# REGIONAL REVIEW NOTICE

**ARC REVIEW CODE:** R1701241

**Name of Proposal:** SL Bright Star

**SL BRIGHT STAR DRI**  
**City of Douglasville**  
**Natural Resources Division Review Comments**  
**January 18, 2017**

CONCEPTUAL SITE PLAN  
OF  
**BRIGHT STAR ROAD PROJECT DRI # 2653**  
L.L. 162 & 163, 2nd DISTRICT, 5th SECTION  
CITY OF DOUGLASVILLE, DOUGLAS COUNTY, GEORGIA

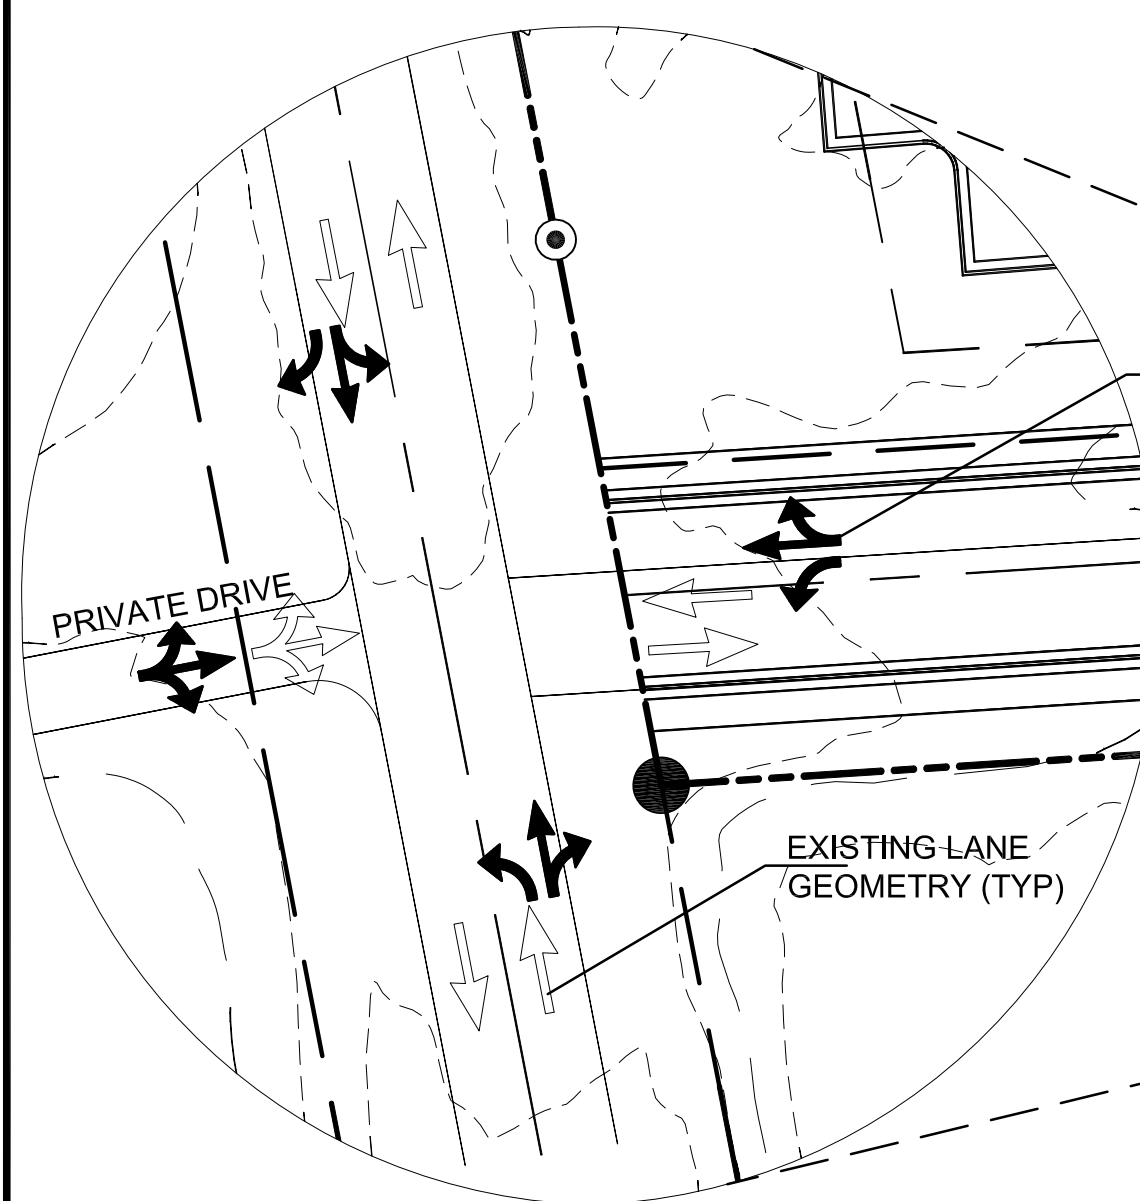
The USGS coverage for the project area shows a blue line stream that is either the headwaters of Anneewakee Creek or a direct tributary originating on the property. The project site plan shows the stream as starting at the eastern edge of the property, just east of a proposed driveway/parking area. The submitted site plan shows that driveway area intruding on the City's 50-foot stream buffer at the headwaters of the stream. It also intrudes on the City's additional 25-foot impervious setback, which is immediately adjacent to the buffer and is part of the buffer ordinance. Regardless of the stream's location, any intrusion in the buffer or setback will be subject to the requirements of the City of Douglasville's Stream Buffer Ordinance. Any unmapped streams on the property may also be subject to the requirements of the City's Stream Buffer Ordinance. In addition, all streams on the property, as well as all waters of the state, are subject to the requirements of the State Erosion and Sedimentation Act, which includes a 25-foot buffer on all state waters.

The subject site is bounded by existing industrial uses on the northern and western boundaries. Parcels east and south of the site remain undeveloped. The development does not propose additional roadways or stub-outs that may provide future interparcel connectivity. It should be noted that Wood Road is currently unpaved. The development is projecting about 2,500 trips per day and proposing seven access drives from Wood Road.

The subject site proposes seven (7) access points off Wood Road. Five of the access points feed into designated parking lots while the other two are drive lanes spanning the entire site. This method appears to segregate proposed employee and visitor vehicular traffic from truck traffic internal to the site.

Interconnectivity and accessibility between parcels is paramount to reduce congestion. The incorporation of opportunities for future interparcel connectivity external to the development site is encouraged.
